South Texas Project Electric Generating Station P.O. Box 289 Wadsworth, Texas 77483

April 15, 2010  
U7-C-STP-NRC-100084

South Texas Project  
Units 3 and 4  
Docket Nos. 52-012 and 52-013  
Response to Request for Additional Information

Figure 3.0-1 UHS and Reactor Service Water System

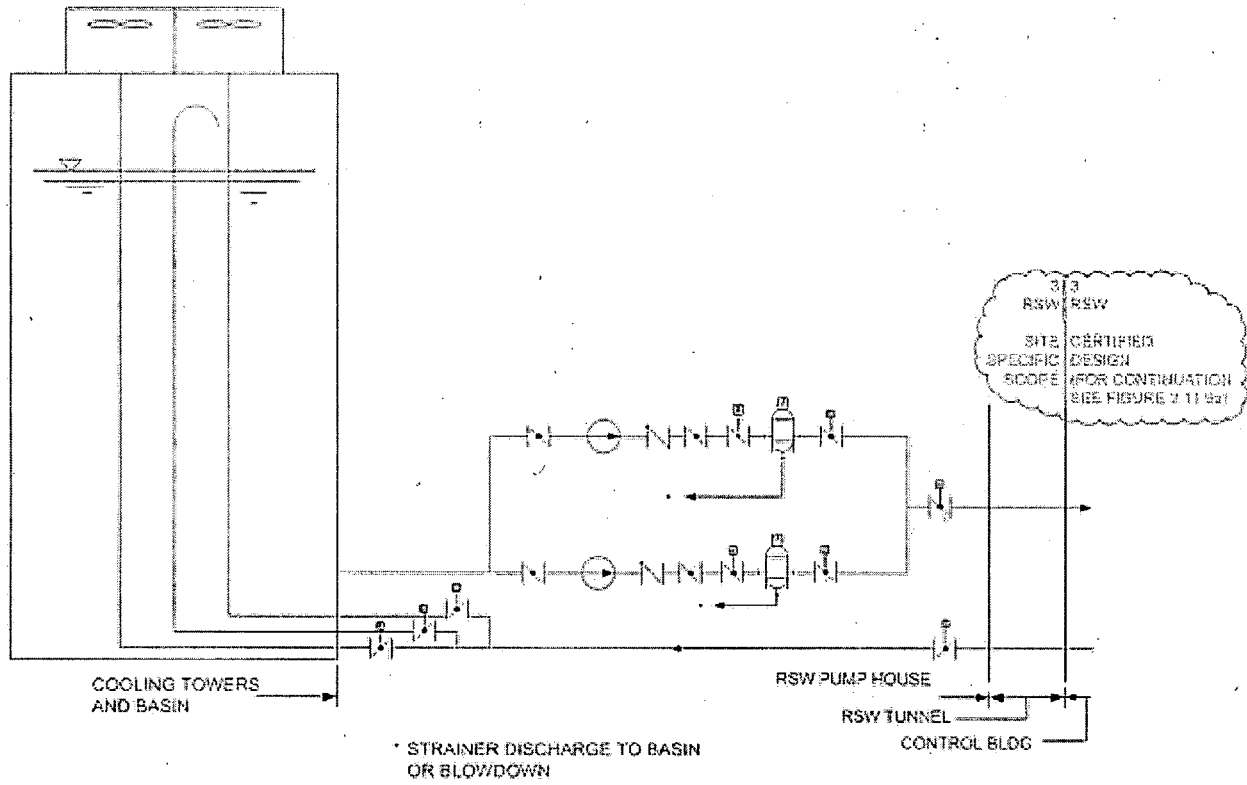
Rather than including a licensing commitment to update the FSAR figures to include the QG, the response to RAI 03.02.02-2 references the Tables for QG classifications. Although NRC staff can audit detailed P&IDs during the detailed design stage, QG boundaries should also be shown on the simplified P&IDs in the COL FSAR. SRP 3.2.2 states that the P&IDs are reviewed to ensure that the applicant has delineated in detail the system quality group classification boundaries for systems important to safety and SRP 14.3 Appendix C states that the functional drawings identify the boundaries of the ASME Code classification that are applicable to the safety class. Considering the revised response to RAI 03.02.02-6 relative to ITAAC, a licensing commitment should also be cited by the applicant to update FSAR figures for P&IDs prior to fuel load, including an appropriate implementation schedule. If the applicant plans to include the quality group/ASME Code boundaries during the annual updates the staff will defer this review of P&IDs until later.

The site specific representation of the Ultimate Heat Sink (UHS) and Reactor Service Water System is included in COLA Part 9, Section 3.0, Site-Specific ITAAC as Figure 3.0-1. Although the figure used the Tier 1 line symbol representative of ASME Code Class 3 for the piping, there was no Appendix A “designation” that correlated to that classification because there are no code breaks on this figure.

To provide additional clarity, COLA Part 9, Section 3.0, Figure 3.0-1 will be revised to add the ASME Code Class 3 designation to piping on this diagram as indicated in a gray balloon on the attached figure. There are no QG breaks on this figure.
